Number: 737-28-1330
Original Issue: March 27, 2015
ATA System: 2822

SUBJECT: FUEL - DISTRIBUTION - Engine Fuel Feed System - Auxiliary Power Unit (APU) Fuel Feed Line Replacement

BOEING SERVICE BULLETIN 737-28-1330

FIGURE 1: APU HOSE ASSEMBLY REPLACEMENT
(SHEET 1 OF 2)

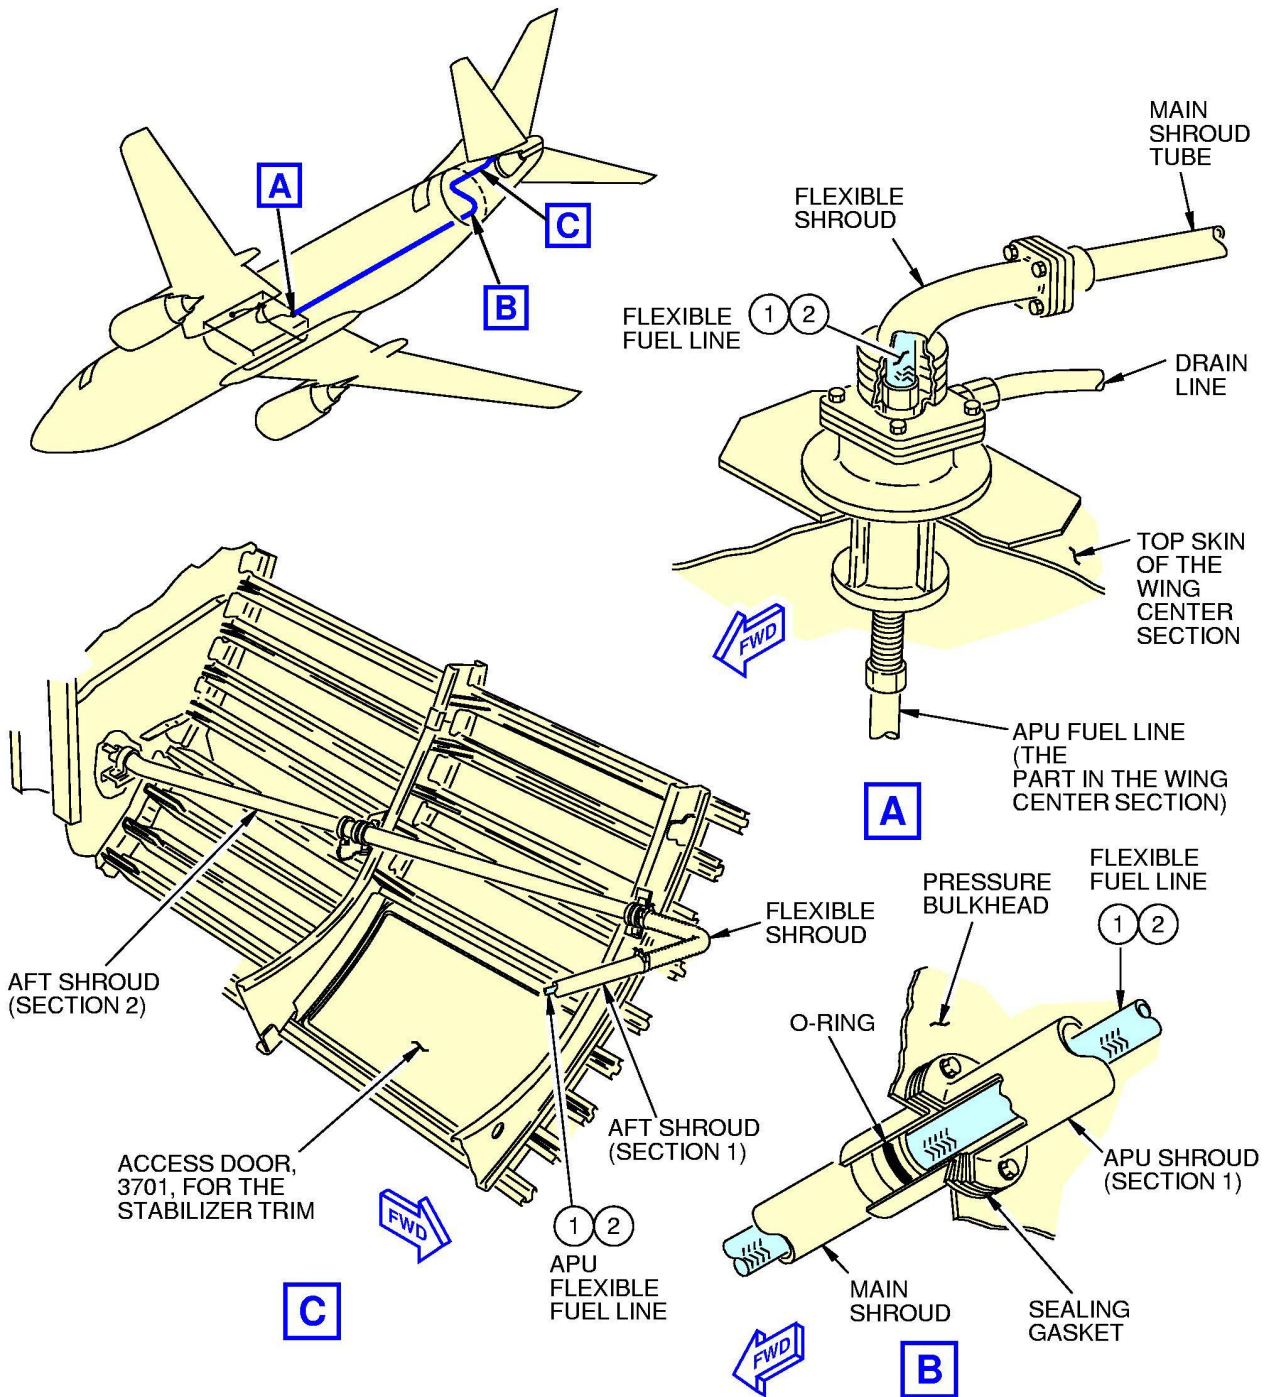
This Figure applies only to: Group 2.

Step	Task	Name	Identification	Qty	More Data
1	Remove	HOSE ASSEMBLY - APU FUEL	B113-6 (10-61221-6)	1	(a)
2	Install (New)	HOSE ASSEMBLY - APU FUEL	B920EEE5010D (60B92407-76)	1	(a)
(a) Refer to 737-100/200 AMM 28-22-81 as an accepted procedure.

Name	Existing Part Number	New Part Number	QTY
Hose Assembly - APU Fuel	B113-6 (10-61221-6) (a)	B920EEE5010D (60B92407-76) (b)	1
(a) Stratoflex part number: B113-6.			
(b) Parker - Stratoflex part number: B920EEE5010D.

**FIGURE 2: APU HOSE ASSEMBLY REPLACEMENT
(SHEET 1 OF 2)**

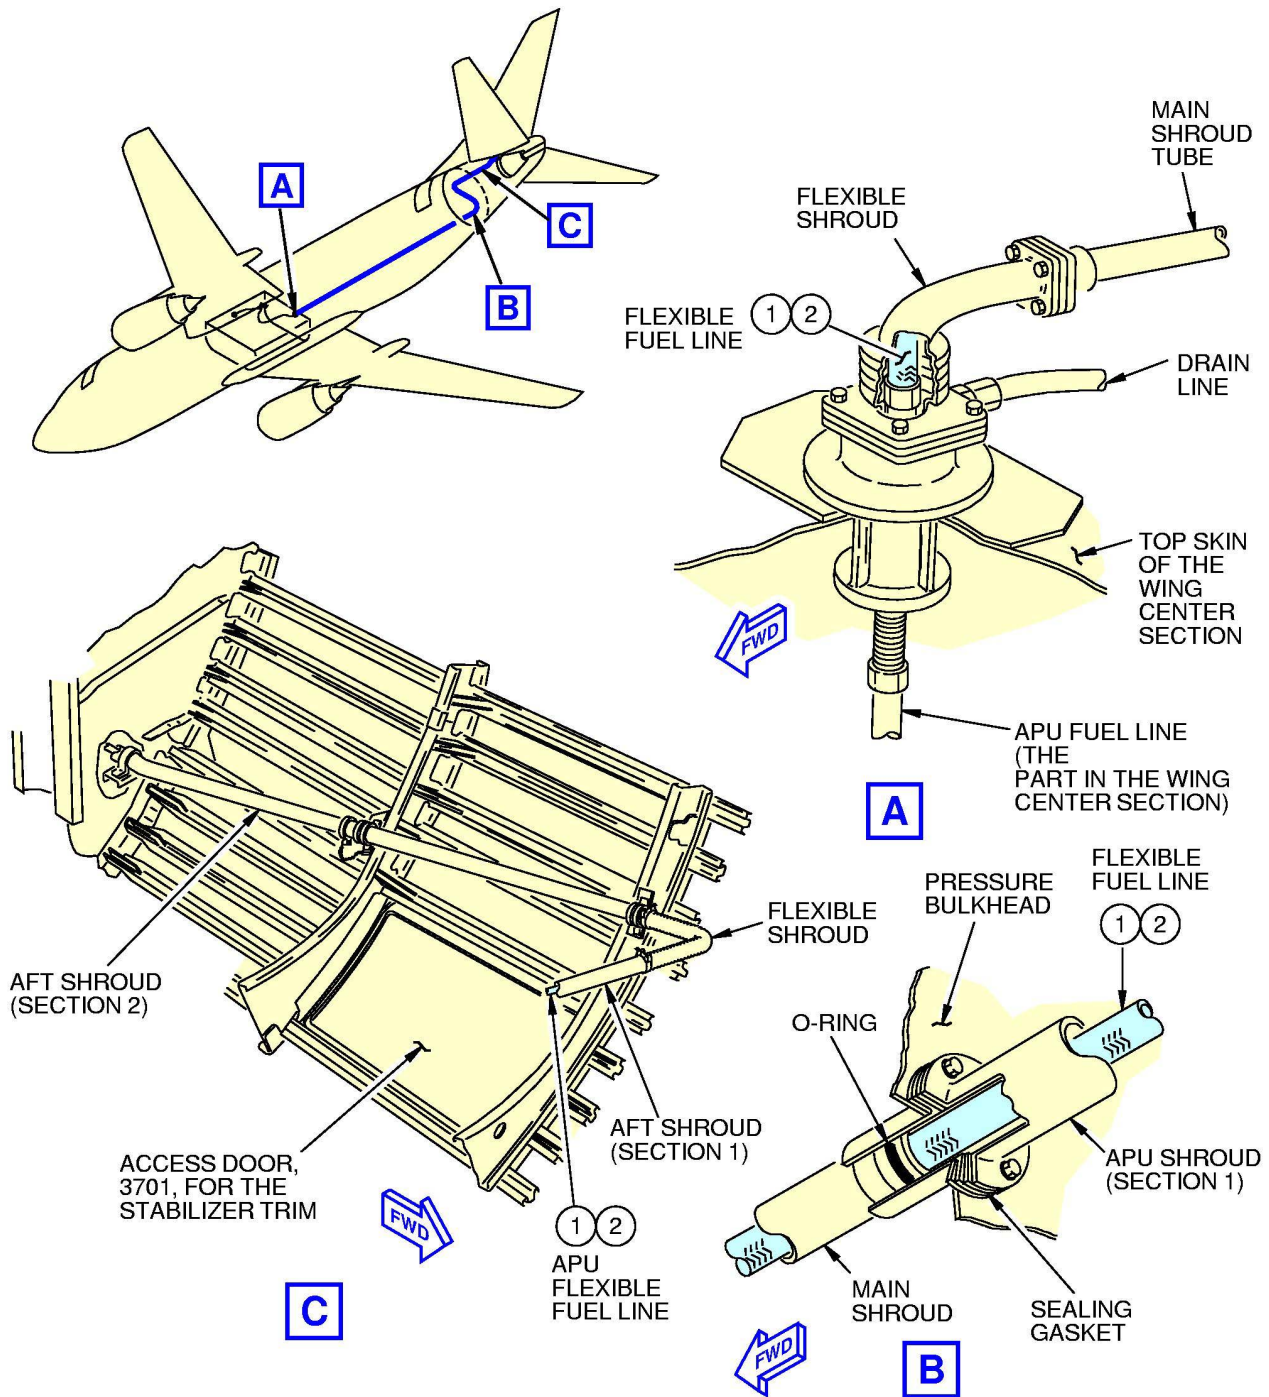
This Figure applies only to: Group 3.

Step	Task	Name	Identification	Qty	More Data
1	Remove	HOSE ASSEMBLY - APU FUEL	B113-10 (10-61221-10)	1	(a)
2	Install (New)	HOSE ASSEMBLY - APU FUEL	B920EEE5000D (60B92407-77)	1	(a)
(a) Refer to 737-100/200 AMM 28-22-81 as an accepted procedure.

Name	Existing Part Number	New Part Number	QTY
Hose Assembly - APU Fuel	B113-10 (10-61221-10) (a)	B920EEE5000D (60B92407-77) (b)	1
(a) Stratoflex part number: B113-10.			
(b) Parker - Stratoflex part number: B920EEE5000D.

FIGURE 3: APU HOSE ASSEMBLY REPLACEMENT
(SHEET 1 OF 2)

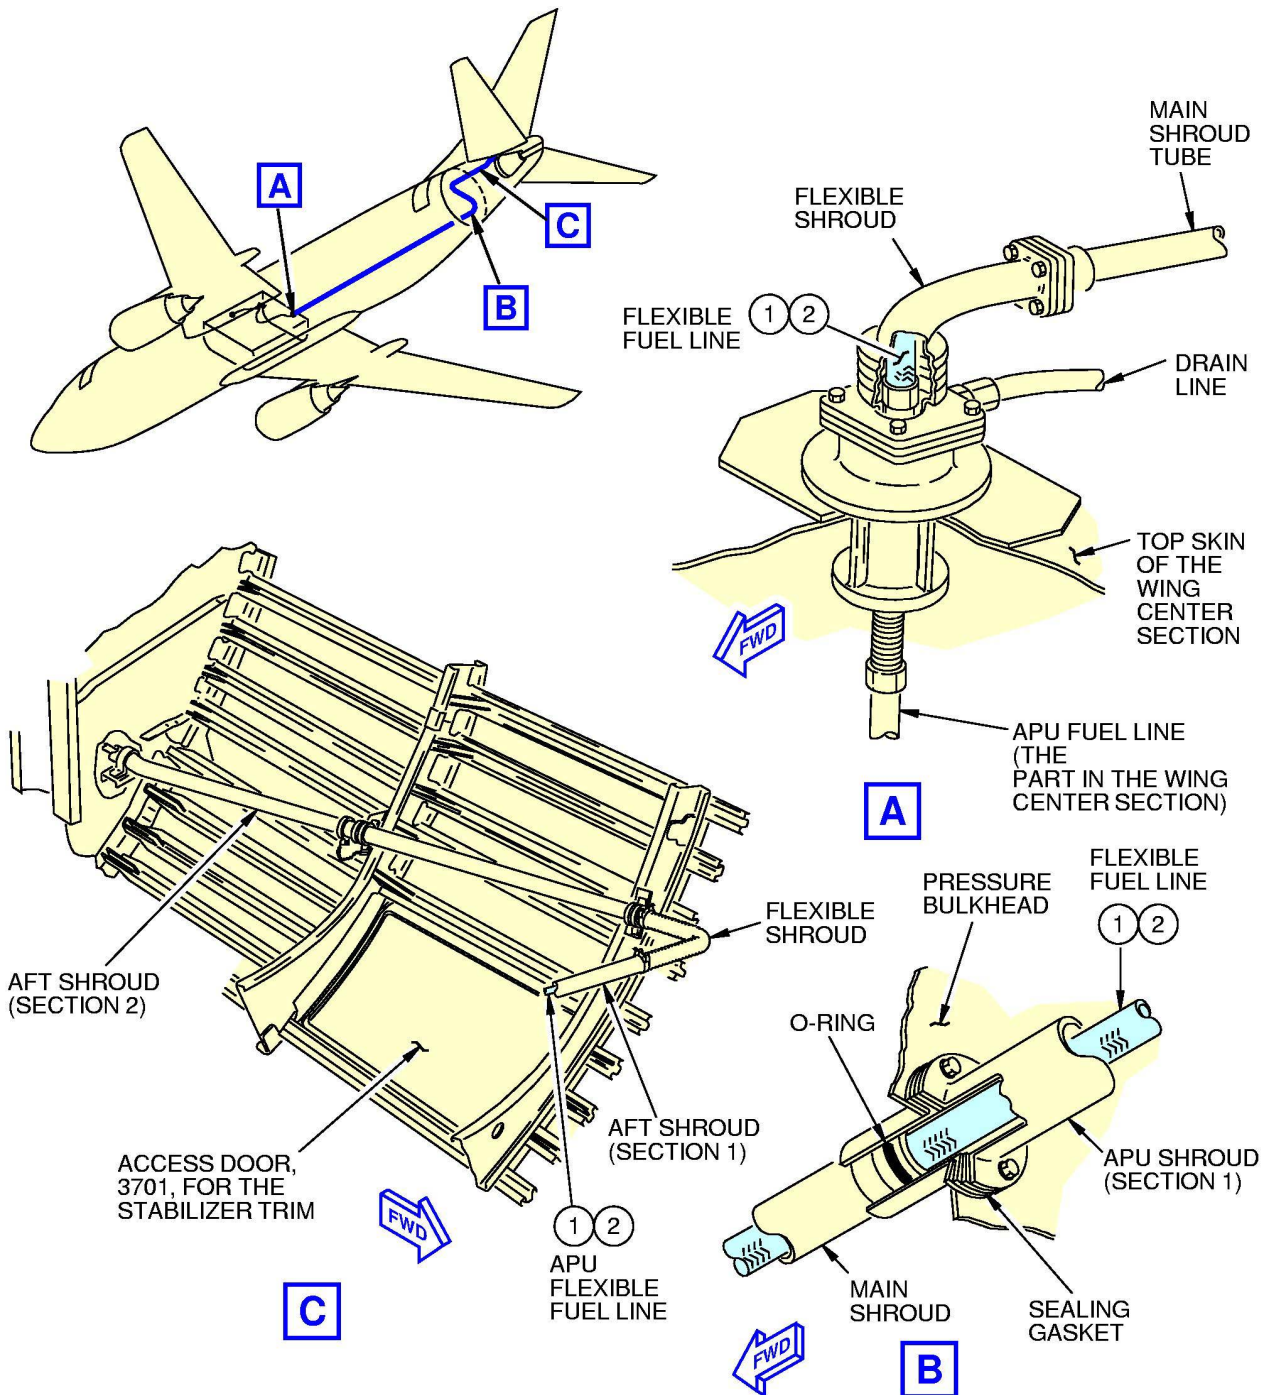
This Figure applies only to: Group 4.

Step	Task	Name	Identification	Qty	More Data
1	Remove	HOSE ASSEMBLY - APU FUEL	B113-9 (10-61221-9)	1	(a)
2	Install (New)	HOSE ASSEMBLY - APU FUEL	B920EEE5610D (60B92407-72)	1	(a)
(a) Refer to 737-300/400/500 AMM 28-22-81 as an accepted procedure.

Name	Existing Part Number	New Part Number	QTY
Hose Assembly - APU Fuel	B113-9 (10-61221-9) (a)	B920EEE5610D (60B92407-72) (b)	1
(a) Stratoflex part number: B113-9.			
(b) Parker - Stratoflex part number: B920EEE5610D.

FIGURE 4: APU HOSE ASSEMBLY REPLACEMENT
(SHEET 1 OF 2)

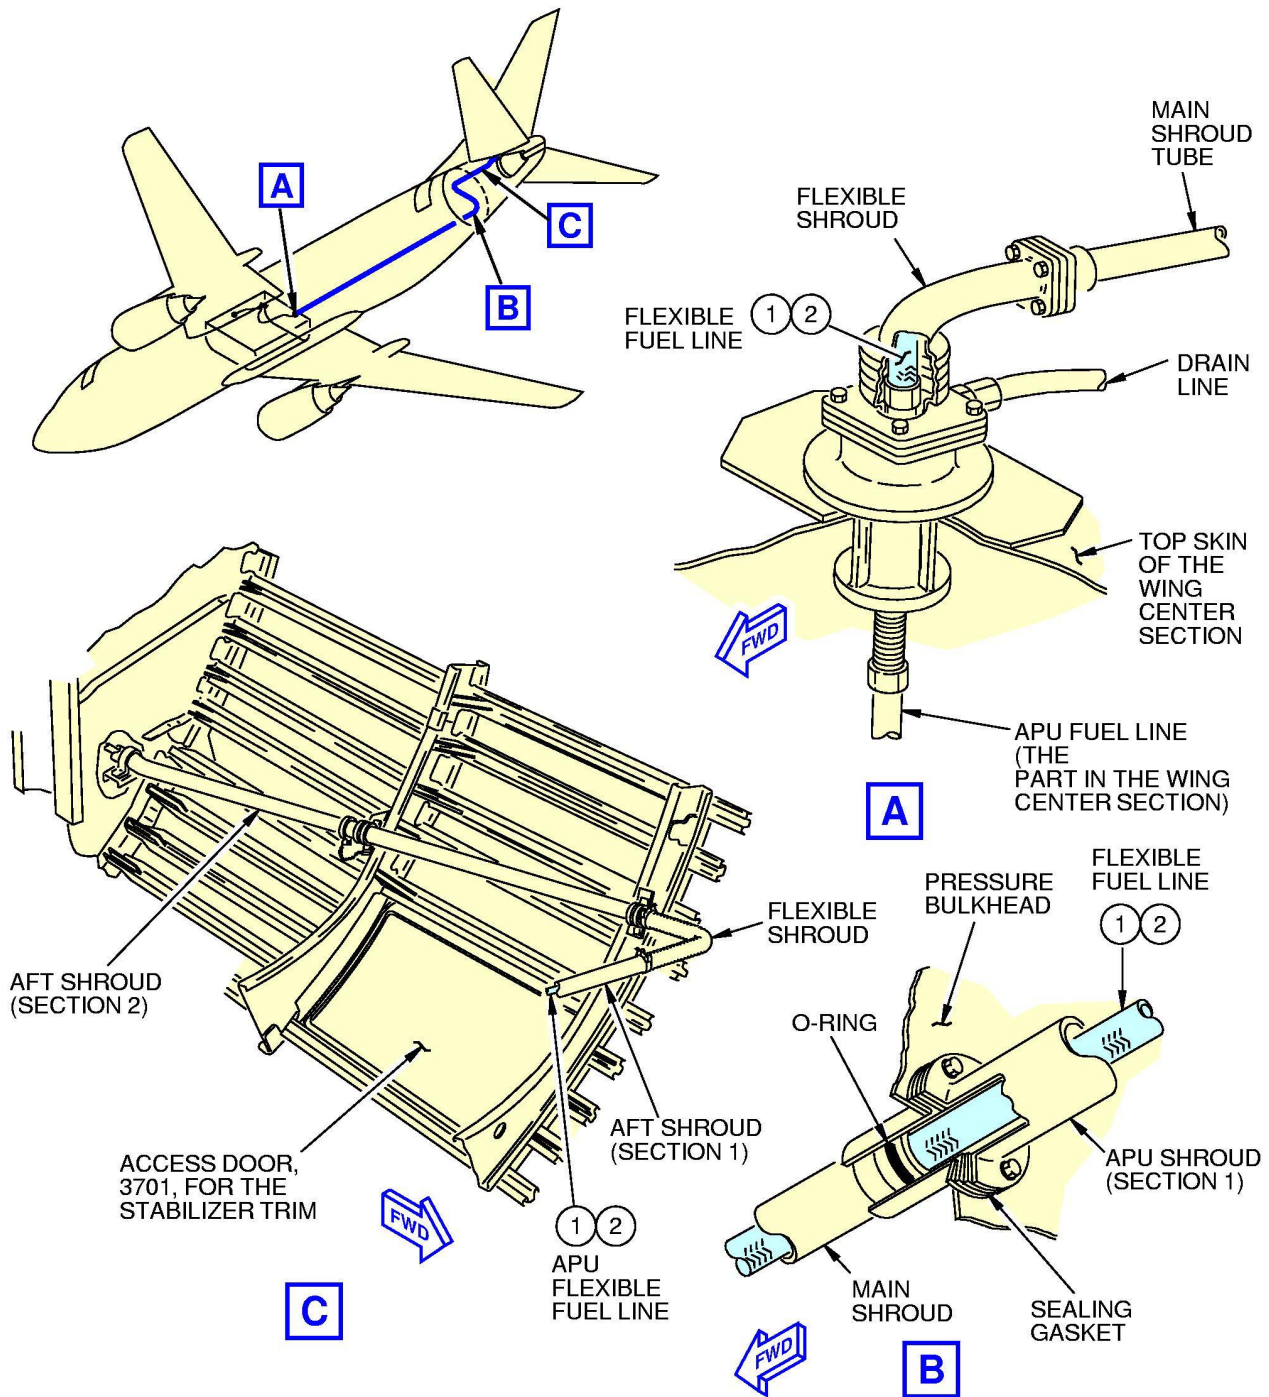
This Figure applies only to: Group 5.

Step	Task	Name	Identification	Qty	More Data
1	Remove	HOSE ASSEMBLY - APU FUEL	B113-11 (10-61221-11)	1	(a)
2	Install (New)	HOSE ASSEMBLY - APU FUEL	B920EEE5600D (60B92407-73)	1	(a)
(a) Refer to 737-300/400/500 AMM 28-22-81 as an accepted procedure.

Name	Existing Part Number	New Part Number	QTY
Hose Assembly - APU Fuel	B113-11 (10-61221-11) (a)	B920EEE5600D (60B92407-73) (b)	1
(a) Stratoflex part number: B113-11.			
(b) Parker - Stratoflex part number: B920EEE5600D.

FIGURE 5: APU HOSE ASSEMBLY REPLACEMENT
(SHEET 1 OF 2)

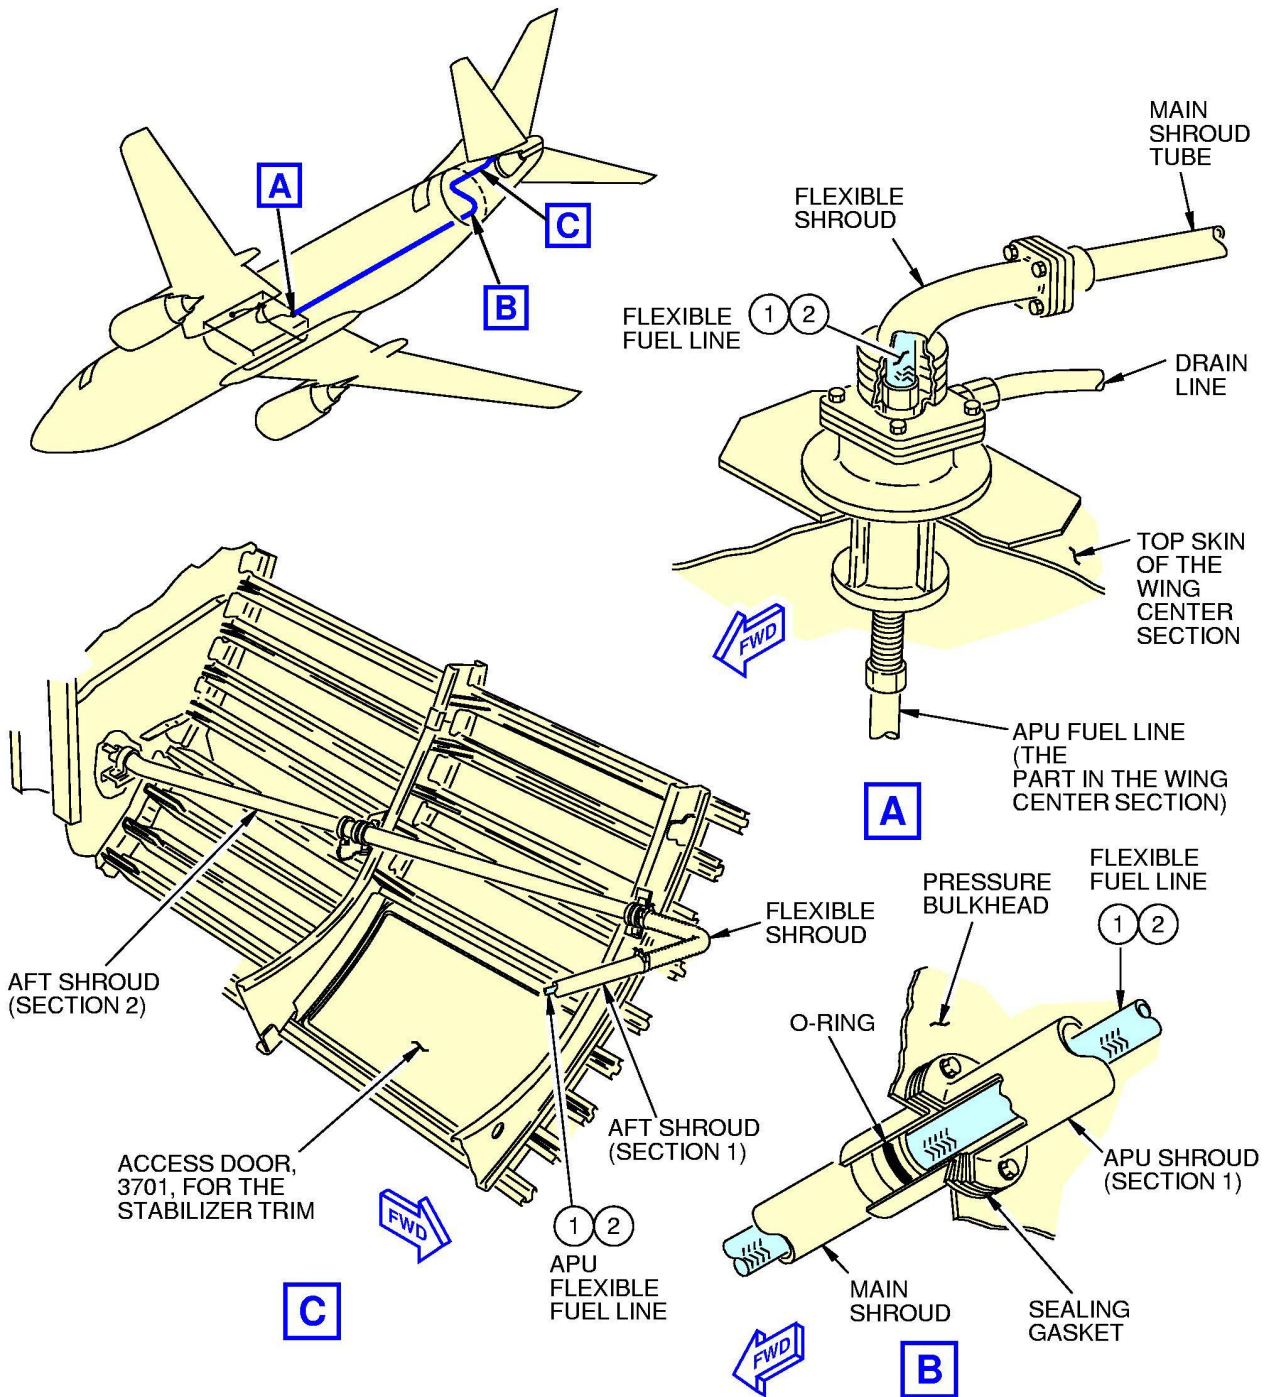
This Figure applies only to: Group 6.

Step	Task	Name	Identification	Qty	More Data
1	Remove	HOSE ASSEMBLY - APU FUEL	B113-12 (10-61221-12)	1	(a)
2	Install (New)	HOSE ASSEMBLY - APU FUEL	B920EEE6080D (60B92407-74)	1	(a)
(a) Refer to 737-300/400/500 AMM 28-22-81 as an accepted procedure.

Name	Existing Part Number	New Part Number	QTY
Hose Assembly - APU Fuel	B113-12 (10-61221-12) (a)	B920EEE6080D (60B92407-74) (b)	1
(a) Stratoflex part number: B113-12.			
(b) Parker - Stratoflex part number: B920EEE6080D.

FIGURE 6: APU HOSE ASSEMBLY REPLACEMENT
(SHEET 1 OF 2)

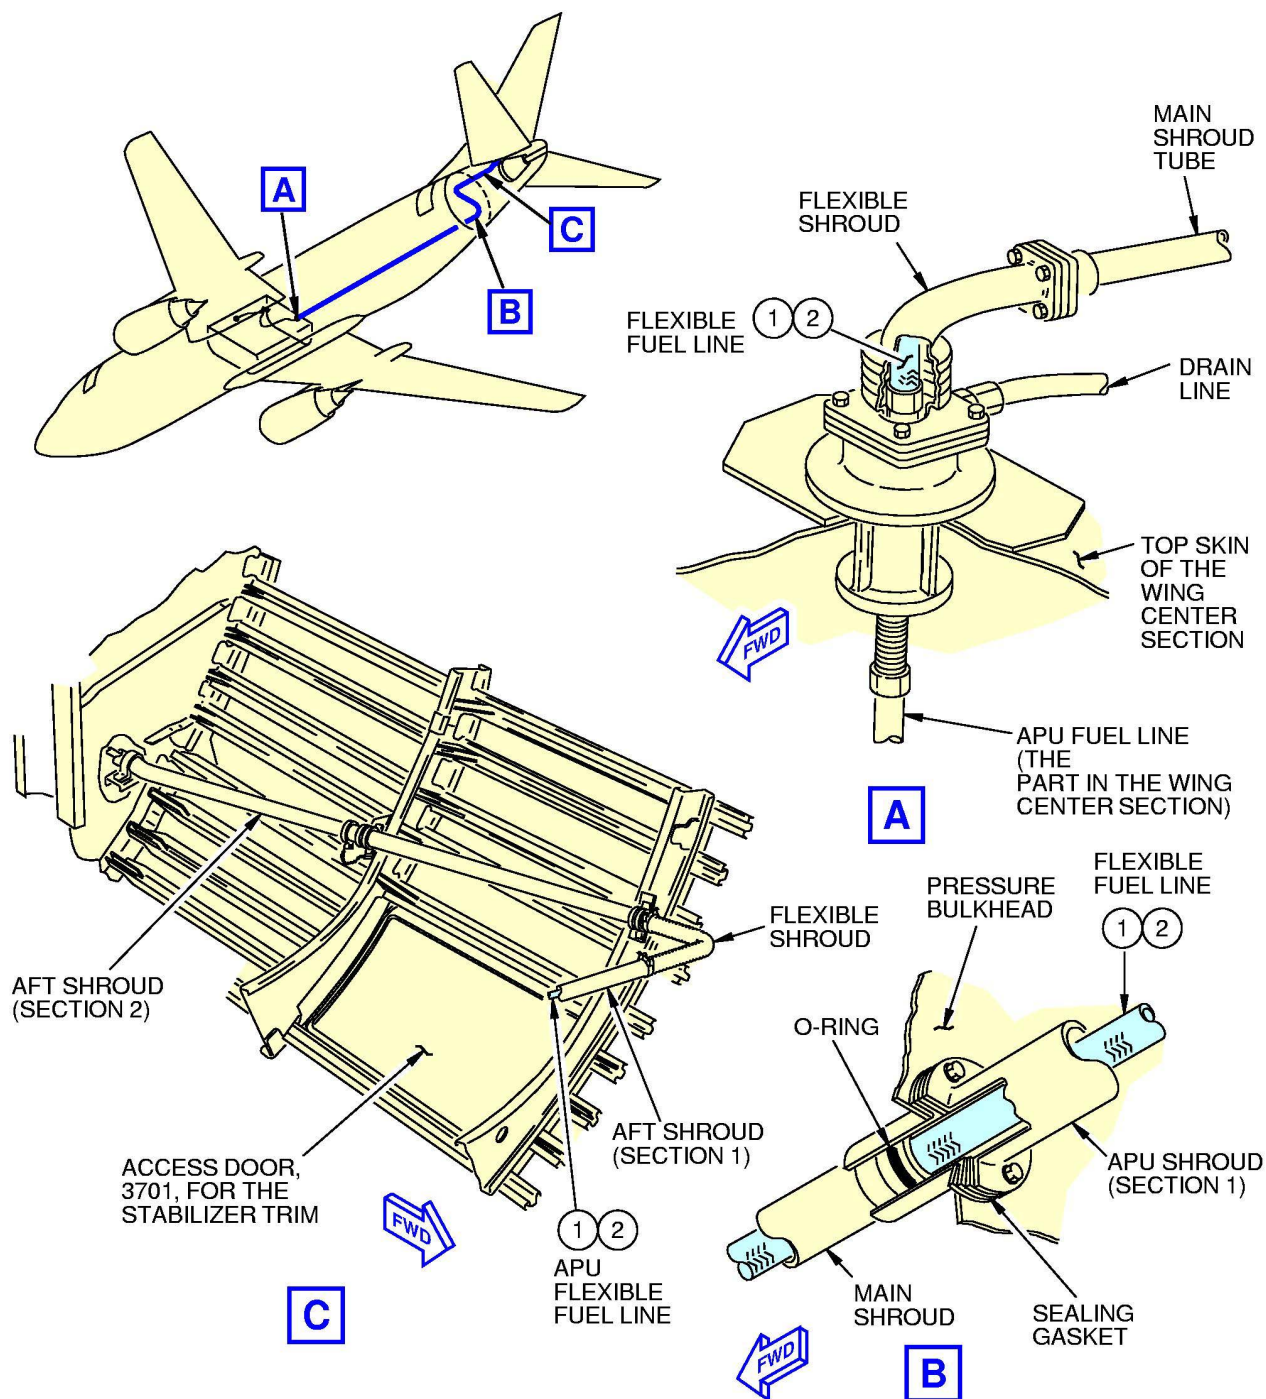
This Figure applies only to: Group 7.

Step	Task	Name	Identification	Qty	More Data
1	Remove	HOSE ASSEMBLY - APU FUEL	B113-13 (10-61221-13)	1	(a)
2	Install (New)	HOSE ASSEMBLY - APU FUEL	B920EEE5200D (60B92407-68)	1	(a)
(a) Refer to 737-300/400/500 AMM 28-22-81 as an accepted procedure.

Name	Existing Part Number	New Part Number	QTY
Hose Assembly - APU Fuel	B113-13 (10-61221-13) (a)	B920EEE5200D (60B92407-68) (b)	1
(a) Stratoflex part number: B113-13.			
(b) Parker - Stratoflex part number: B920EEE5200D.
